APPLICATION NO.	FILING DATE	FIRST NAMED INVENTOR	ATTORNEY DOCKET NO.	CONFIRMATION NO.
10/736,336	12/15/2003	Hyunjun Kim	P17176	3721
28062	7590	07/31/2006	EXAMINER	
BUCKLEY, MASCHOFF, TALWALKAR LLC			MAI, ANH T	
5 ELM STREET			ART UNIT	
NEW CANAAN, CT 06840			PAPER NUMBER	
			2832

DETAILED ACTION

Continued Examination Under 37 CFR 1.114

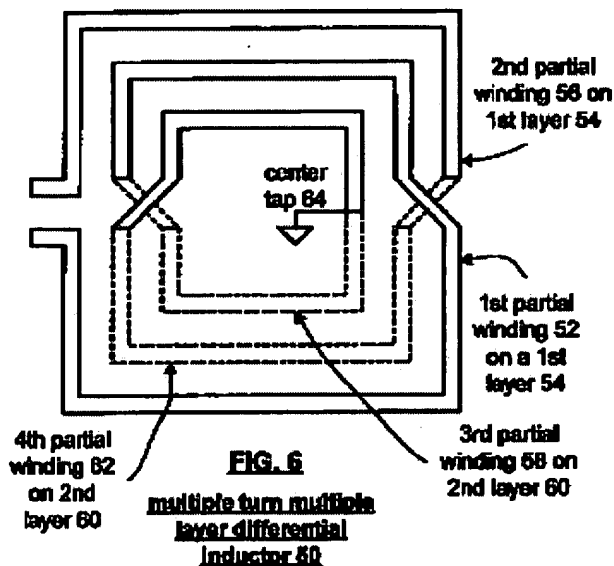
Wakamatsu discloses:

- a first portion of a spiral inductor L1 disposed in a first layer of multilayer substrate;
- second portion of spiral inductor L2 disposed in a second layer of multilayer substrate;
- a shielding plane [ground plane] disposed between the first portion and the second portion of the inductor [figure 3].

Wakamatsu discloses the invention as claimed as cited above except for the second portion of the inductor coupled at a plurality of locations to the first portion. Kyriazidou discloses a multilayer inductor having first portion of winding 12 on first layer 14 of integrated circuit, second portion winding 16 on first layer, third portion winding 18 on second layer 20 of integrated circuit; the first portion winding 12 connected to third portion winding 18 by interconnecting 24, second winding portion 16 connected to fourth winding portion 22 by interconnecting structure 24; an imaginary vector normal to a first section of the inductor 52 on a first layer 54 will not intersect any other section of the inductor [figure 6; col 5, lines 32-39]. At the time of the invention, it would have been obvious to a person of ordinary skill in the art to use the multiple layer inductor as taught by Kyriazidou to the inductor as disclosed by Wakamatsu. The motivation would have been to minimize the use of integrated circuit real estate, operates at high frequencies and has a relatively high Q factor [col 4, lines 65-68]. Therefore, it would have been obvious to combine Wakamatsu with Kyriazidou.

With respect to claim 3, current is to flow in the first direction in the first portion and second direction in second portion opposite to the first direction [figure 3].

With respect to claim 6, Kyriazidou discloses vias 24 coupled the first and second portions.

With respect to claim 7, Wakamatsu discloses pin holes 9 coupled the first and second portions.

With respect to claim 8, dielectric layer 7a disposed between first layer and shielding plane and layer 6a disposed between second layer and shielding plane.
